RAILROAD GRADE CROSSING TRAFFIC CONTROL DEVICES

ORIGINATION FORM -

Proposed Revisions to a Standard Plans Index

Contact Information:	Standard Plans:
Date: June 20, 2023	Index Number: 509-070
Originator: Kelli Phillips	Sheet Number (s): 1, 2, and 3 of 3
Phone: (850) 414-4553	Index Title: Railroad Grade Crossing Traffic Control Devices
Email: Kelli.Phillips@dot.state.fl.us	
Summary of the changes:

MEDIAN SECTION AT SIGNAL GATES

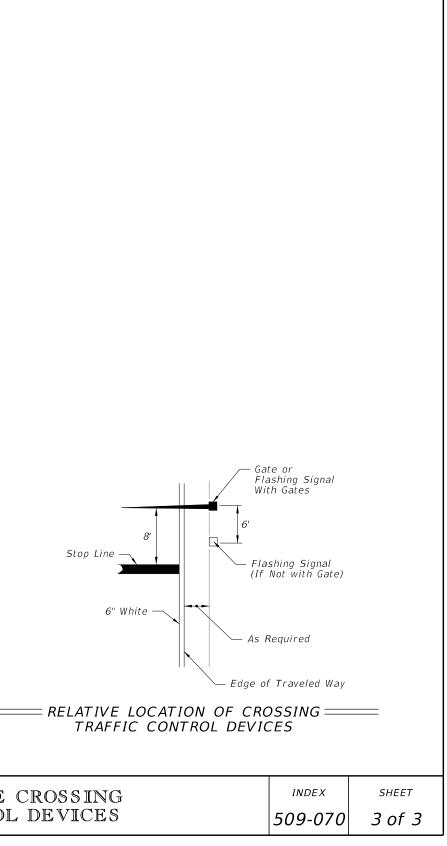
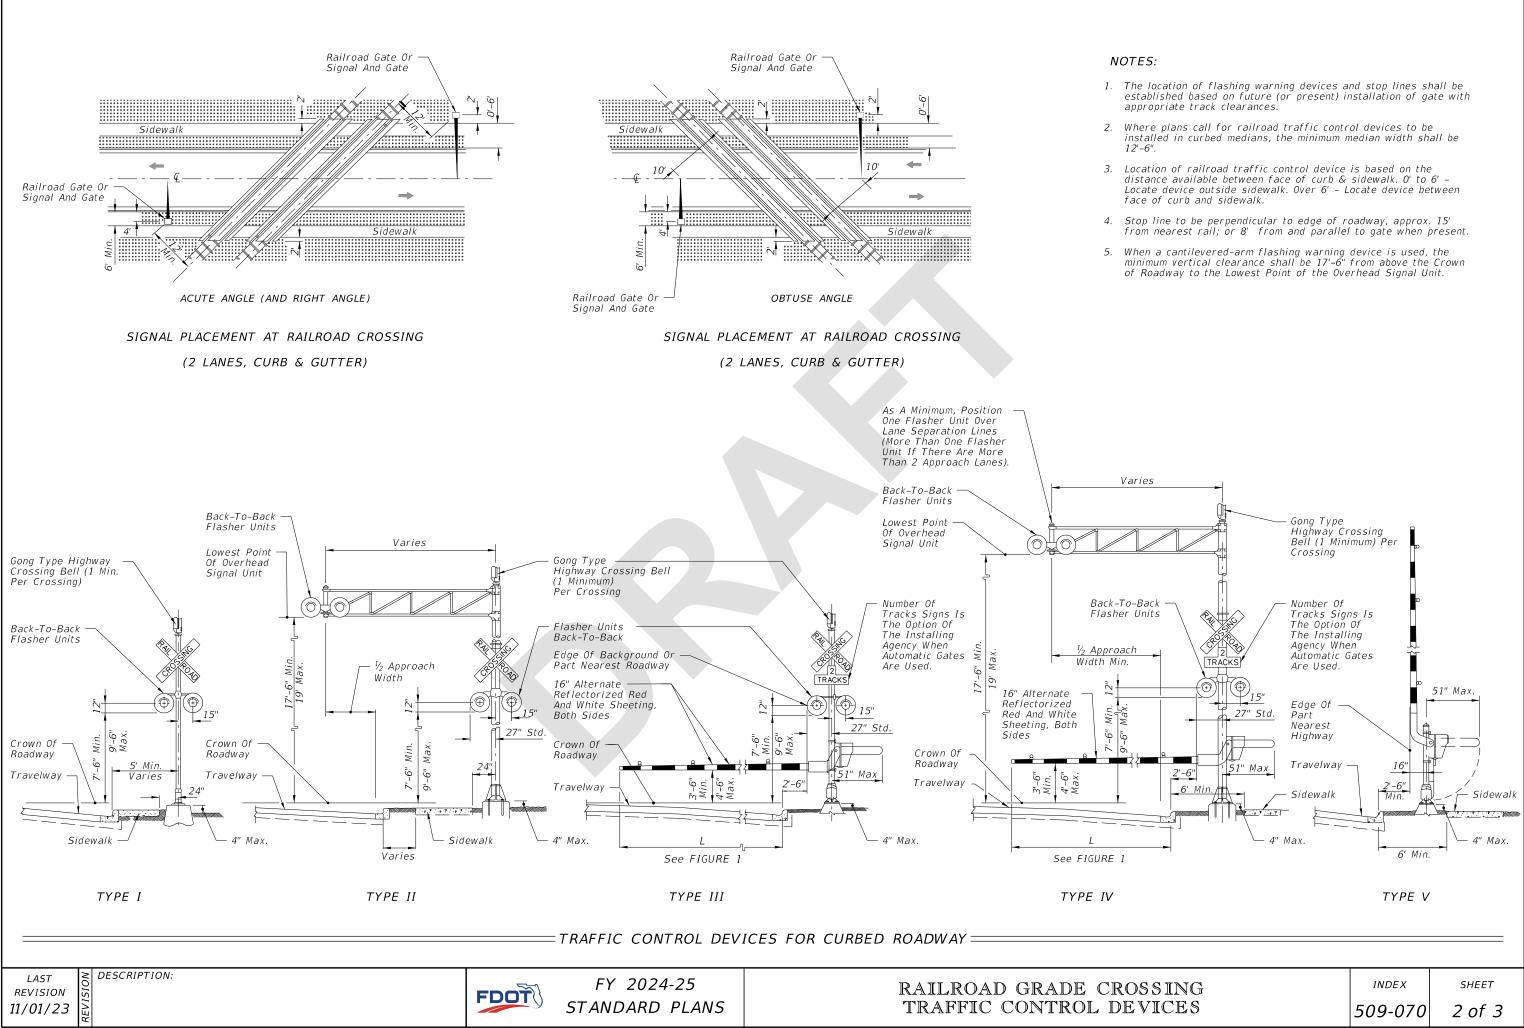
- Sheet 1: Change General Note 5 , Class VI to 3-4; Delete Type V and Type VI from Traffic Control Devices for Flush Shoulder Roadway Details: Added "Std." to the 27" dimension in Type I through Type V.
- Sheet 2: Added "Std." to the 27" dimension in Type II through Type IV.
- Sheet 3: Change 12'-5" min to 12'-6" Min. in PLAN; Change 51" Max to 57" Min in Median Section at Signal Gates Detail.
